DrawDiff Comparison Report

Part number: DA1840189 | Job: 49c6f03e-9d80-4ed0-86c2-1a41475a6533 | Generated: 2026-04-30T02:39:16+00:00

The most critical change to DA1840189 is the apparent removal or significant reduction of a raised rectangular boss/step feature on the upper front face of the bracket, which directly affects part geometry, fit to mating assemblies, and structural function. Supporting this scope of revision, the drawing has been substantially restructured: the SIDE view and VIEW_8 have been removed and replaced with new Section A-A and Section B-B cut views, providing improved internal detail disclosure. Several geometry changes accompany the view restructuring, including the addition of fillets at previously sharp interior pocket corners on the rear face, a modified S-curve transition at the left mounting lug, and a reduction in the count of R.030 radii callouts from 16X to 8X — all of which carry manufacturing and stress-concentration implications. Document control changes are also significant: the drawing number was formalized from placeholder 'XXXXX' to DA1840189, the revision level incremented from NC to A, and the title block revision field was cleared, requir

ANNOTATION [MATCHED]

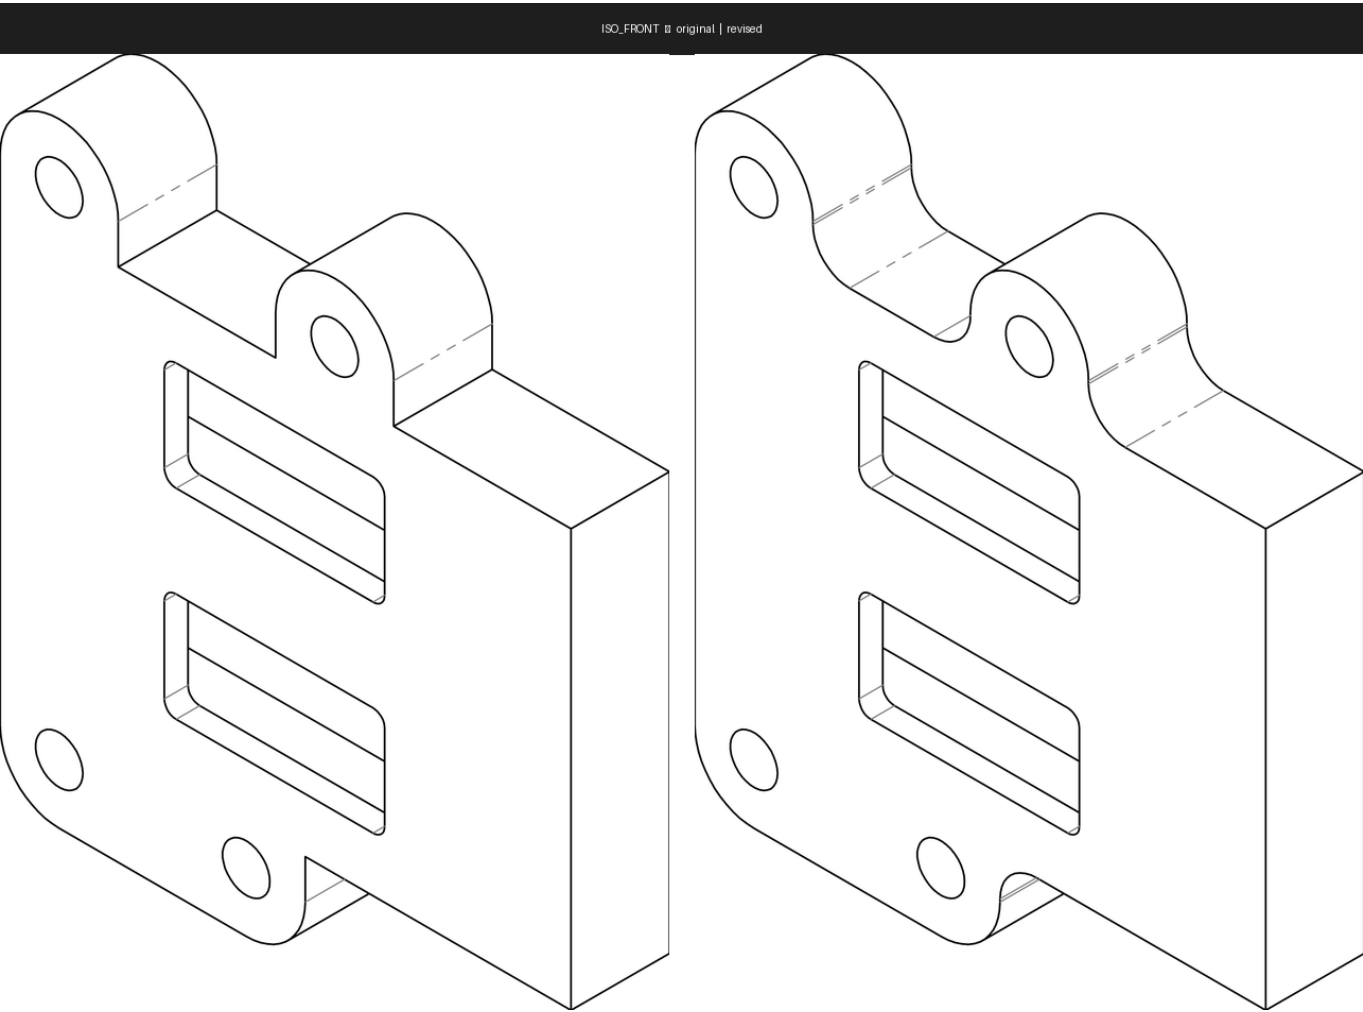
Severity	Field	Original	Revised	Conf.	Rationale
CRITICAL	geometry	Top-left isometric view shows a raised rectangular boss/step feature on the upper portion of the front face of the bracket	Same view shows the raised boss/step feature appears removed or significantly reduced, leaving a more uniform top surface	0.72	The front isometric view appears to show a geometric change on the upper bracket face where a protruding stepped feature visible in the original is not clearly present in the revised view, which could affect fit and function. Impact: Potential removal of a structural boss on the upper front face would alter fit to any mating part that locates against or around that feature — reviewer must verify against assembly interface requirements.
SIGNIFICANT	annotation	REV: NC	REV: A	0.95	The drawing revision level in Note 3 (P/N identification block) changed from NC to A, indicating a formal revision increment that affects part traceability. Impact: Formal revision increment from NC to A affects part traceability and configuration management; all associated BOMs and procurement records must be updated to reference Rev A.

SIGNIFICANT	other	DWG. NO.: XXXXX, SIZE B, SCALE NONE, SHEET 1 OF 3, with NEXT ASSY / USED ON /	DWG. NO.: DA1840189, SCALE NONE, SHEET 1 OF 3; title block reformatted with fewer	0.85	The drawing number changed from placeholder 'XXXXX' to an actual part number 'DA1840189', and the title block layout was

Severity	Field	Original	Revised	Conf.	Rationale
		APPLICATION blocks and projection symbol visible	visible fields and no NEXT ASSY/USED ON/APPLICATION labels		updated, which is significant for document control and part identification. Impact: Placeholder drawing number replaced with actual part number DA1840189; removal of NEXT ASSY/USED ON fields reduces traceability visibility in the title block and should be confirmed as intentional per document control policy.

ISO_FRONT [MATCHED]

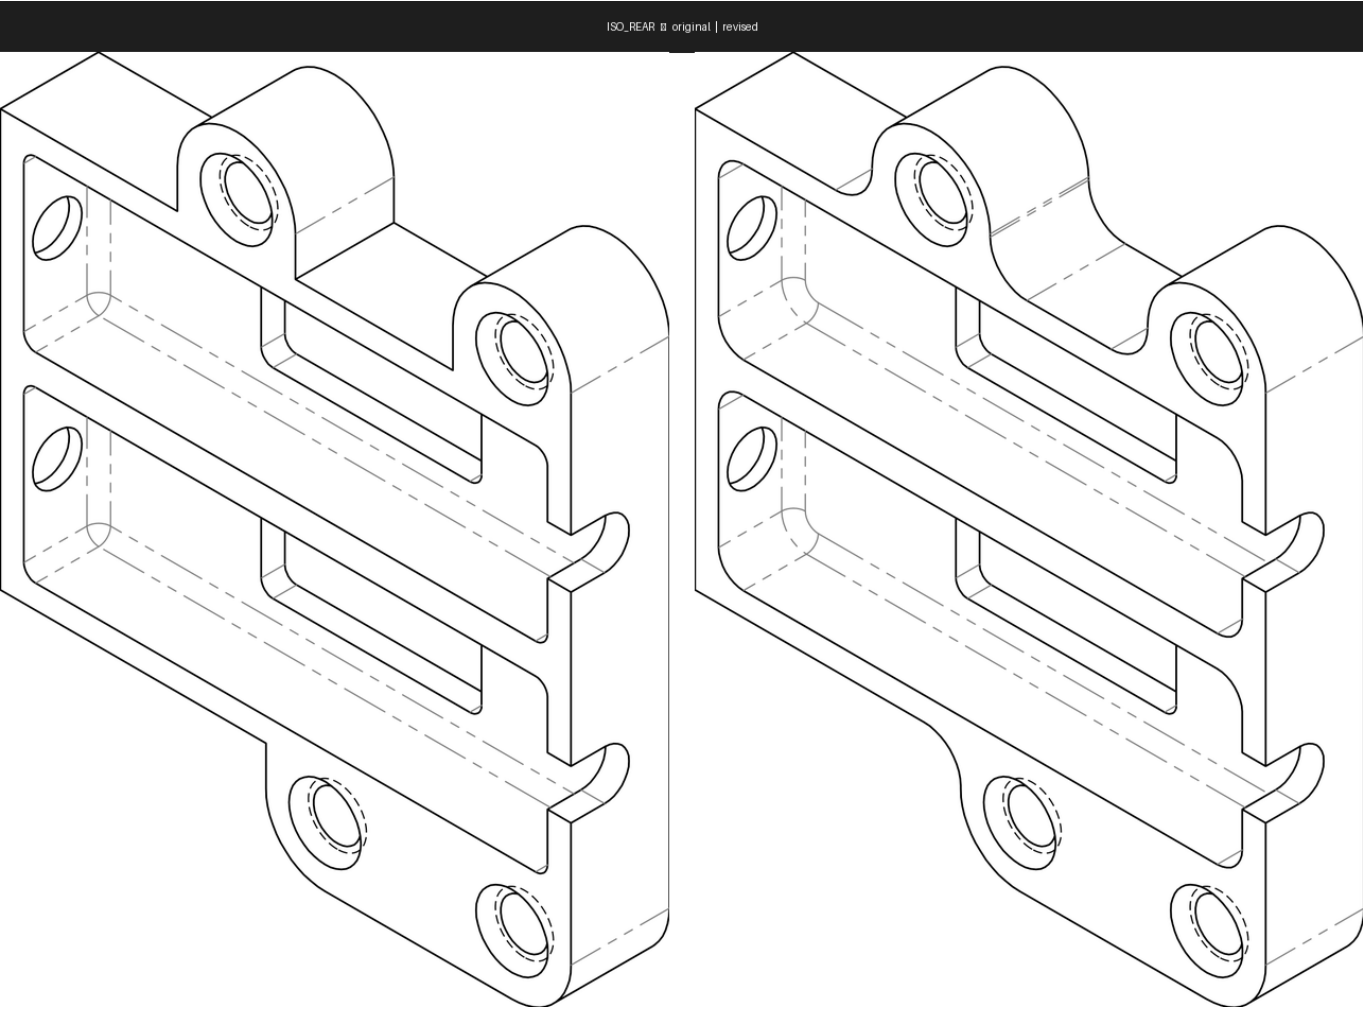
Severity	Field	Original	Revised	Conf.	Rationale
SIGNIFICANT	geometry	Left mounting boss/tab has a straight/angular transition from the rolled cylindrical lug to the flat face	Left mounting boss/tab has a larger, more pronounced curved (S-shaped) transition from the rolled cylindrical lug to the flat face	0.78	The left lug/boss area shows a changed fillet or curved transition geometry between the rolled cylindrical feature and the main body, which affects the structural form and potentially the stress distribution of the bracket.

Severity	Field	Original	Revised	Conf.	Rationale
					Impact: Changed lug-to-body transition geometry affects stress distribution at the mounting boss and may require updated FEA or stress review; toolpath programming for this feature will also need revision.

ISO_REAR [MATCHED]

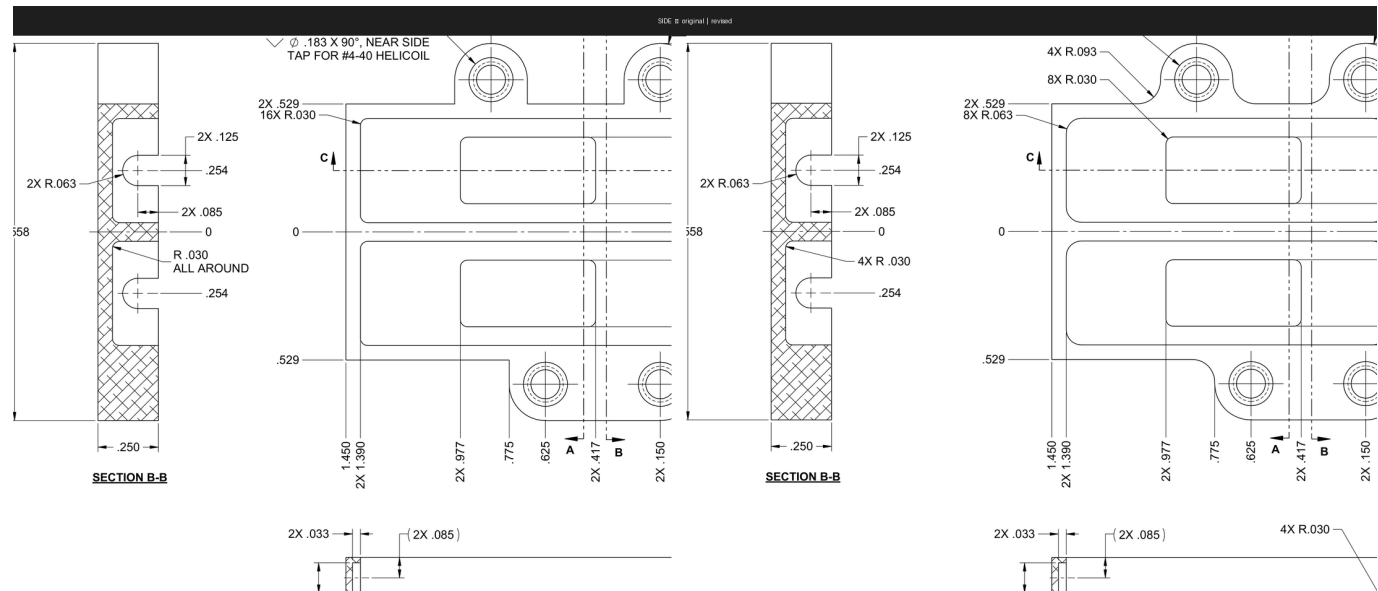
Severity	Field	Original	Revised	Conf.	Rationale
SIGNIFICANT	geometry	Sharp interior corners at left-side vertical edges of upper and lower slot/pocket openings (left face)	Filleted/radiused interior corners at left-side vertical edges of upper and lower slot/pocket openings (left face)	0.75	The revised view shows rounded/filleted transitions at the interior corners of the left-face pocket openings where the original shows sharp corners, indicating a geometry change that affects stress concentration and potentially machining requirements. Impact: Addition of fillets at previously sharp interior pocket corners reduces stress concentration and improves fatigue life, but requires updated machining operations (e.g., radius end mill pass) and inspection criteria.

SIDE [REMOVED]

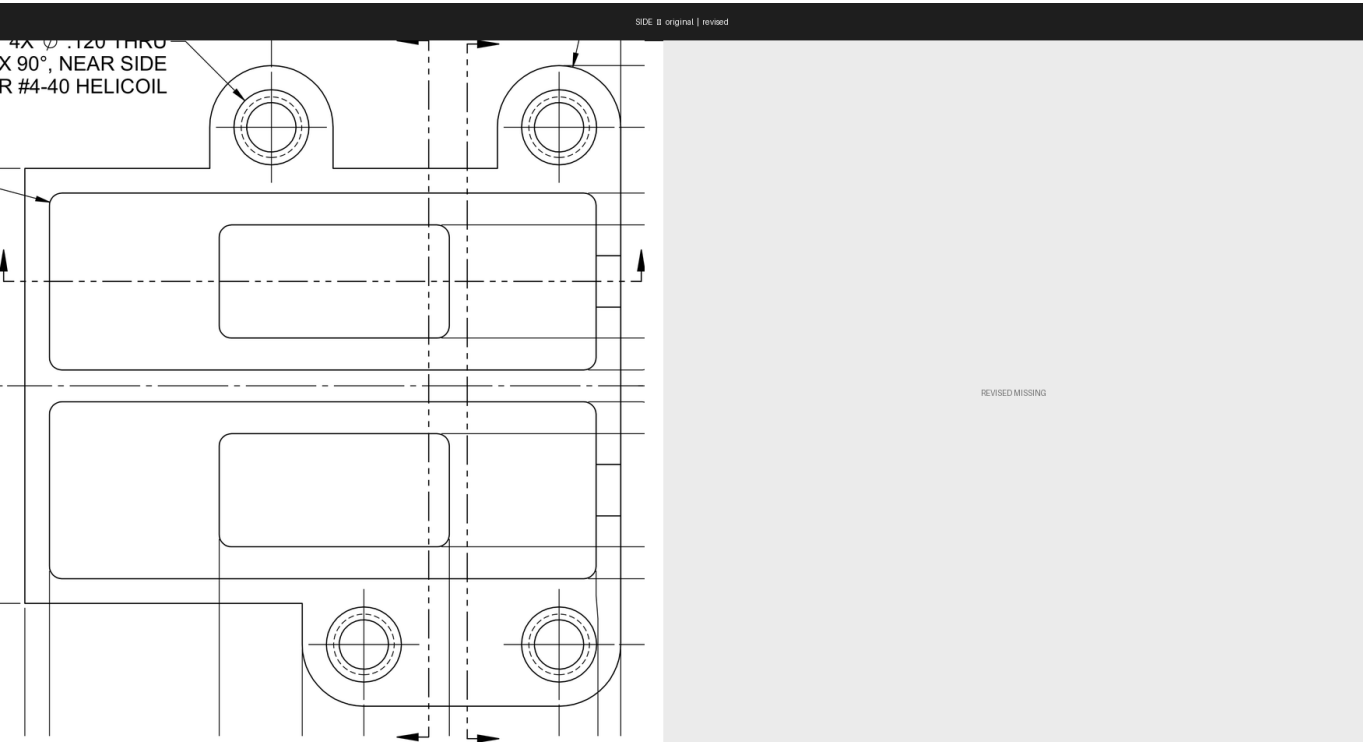
Severity	Field	Original	Revised	Conf.	Rationale
SIGNIFICANT	view	SIDE	—	1.00	View 'SIDE' was present in the original but not the revised drawing. Impact: Removal of the SIDE view reduces orthographic coverage; reviewer should confirm that the new section views (A-A, B-B) fully replace the dimensional and geometric information previously conveyed by this view.

VIEW_8 [REMOVED]

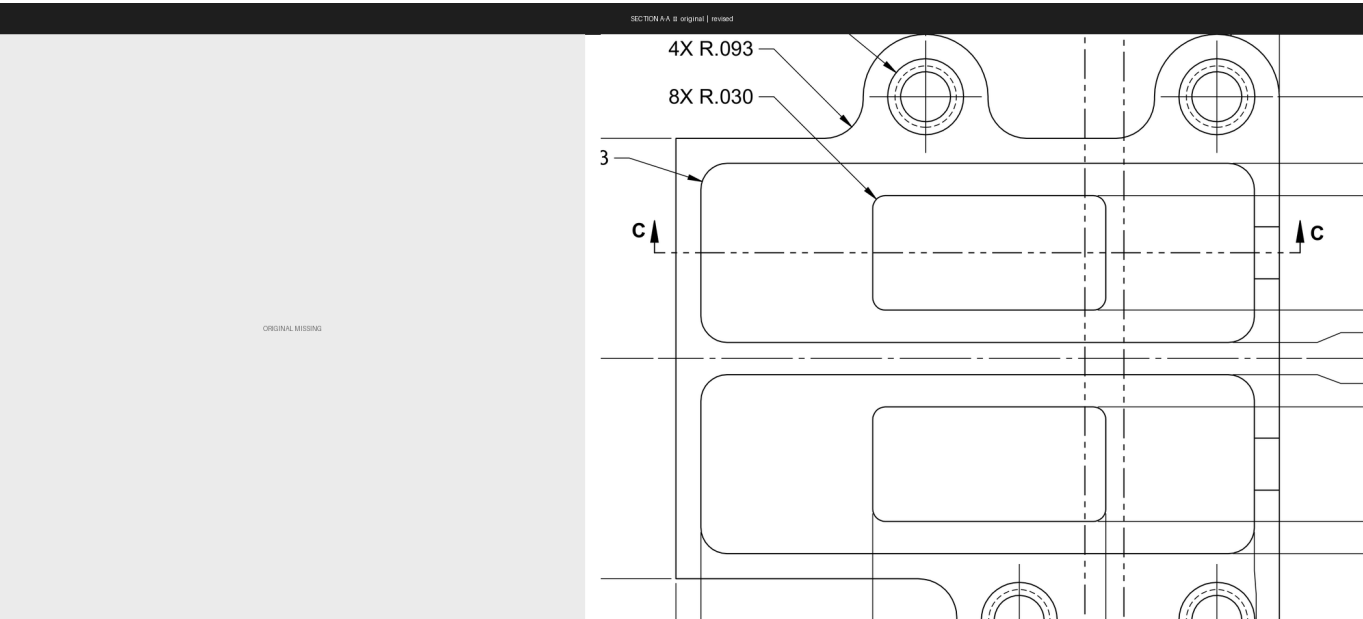
Severity	Field	Original	Revised	Conf.	Rationale
SIGNIFICANT	view	VIEW_8	—	1.00	View 'VIEW_8' was present in the original but not the revised drawing. Impact: VIEW_8 has been removed from the revised drawing; any dimensions or callouts unique to that view must be verified as captured elsewhere in the revised drawing set.

SECTION A-A [ADDED]

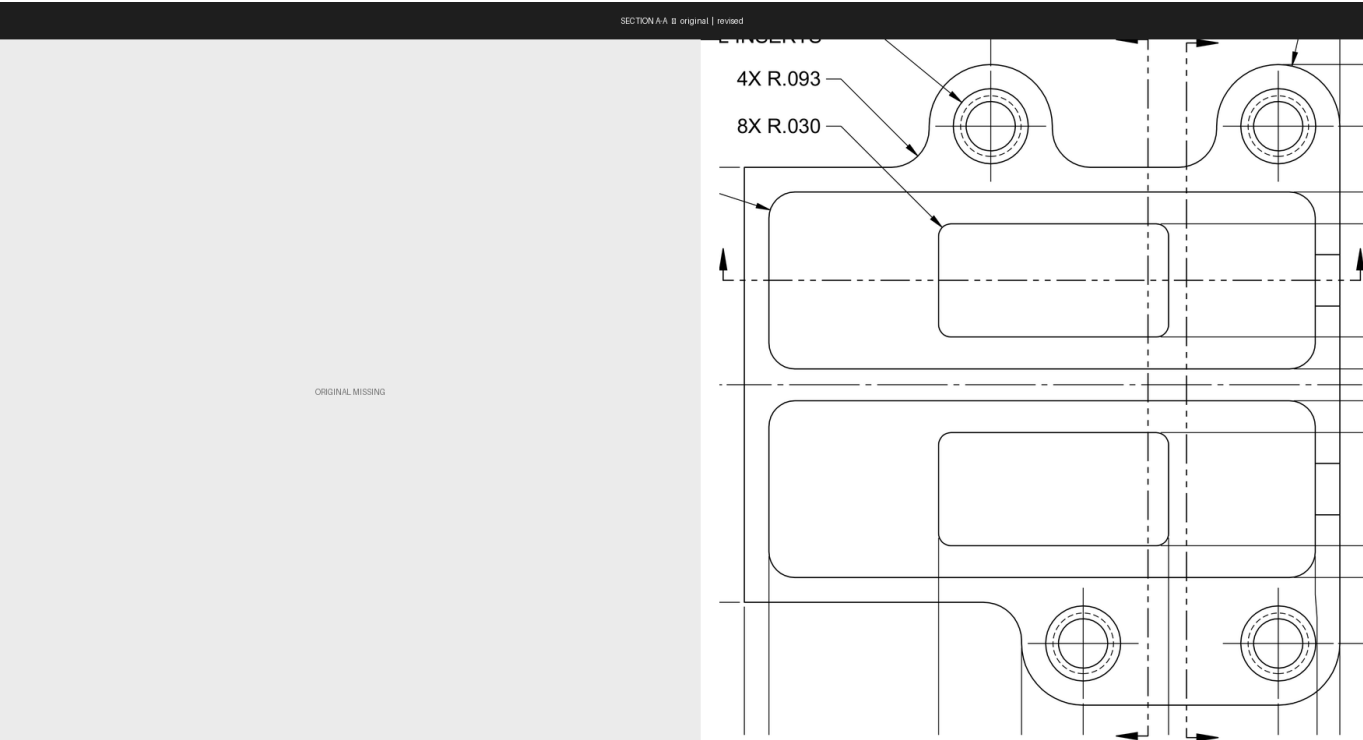
Severity	Field	Original	Revised	Conf.	Rationale
SIGNIFICANT	view	—	SECTION A-A	1.00	View 'SECTION A-A' appears only in the revised drawing. Impact: New Section A-A added to the revised drawing, providing cross-sectional detail not previously shown; manufacturing and inspection must incorporate this view's dimensions and tolerances into their processes.

SECTION B-B [ADDED]

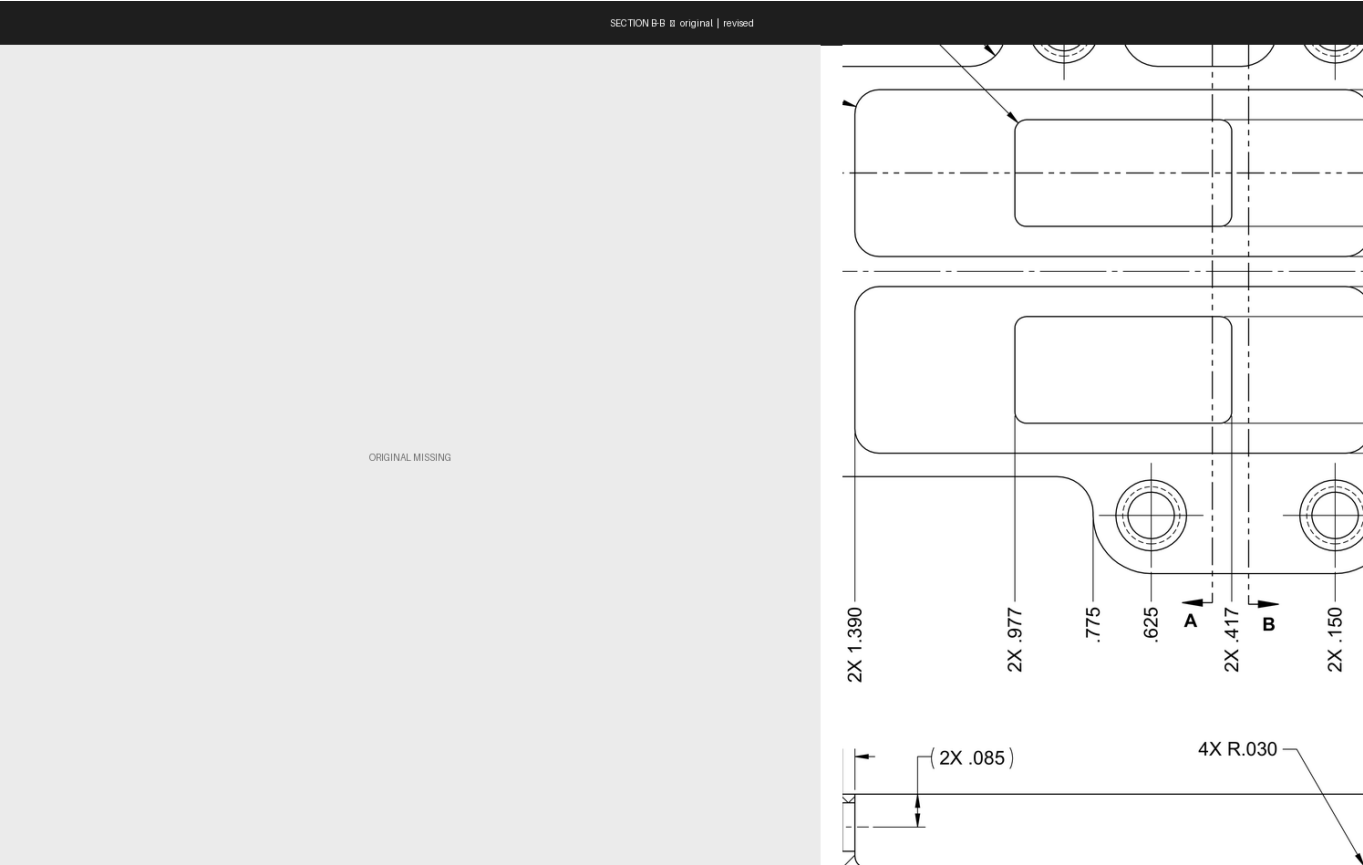
Severity	Field	Original	Revised	Conf.	Rationale
SIGNIFICANT	view	—	SECTION B-B	1.00	View 'SECTION B-B' appears only in the revised drawing. Impact: New Section B-B added to the revised drawing; as with Section A-A, all dimensions and tolerances shown must be incorporated into manufacturing planning and first-article inspection.
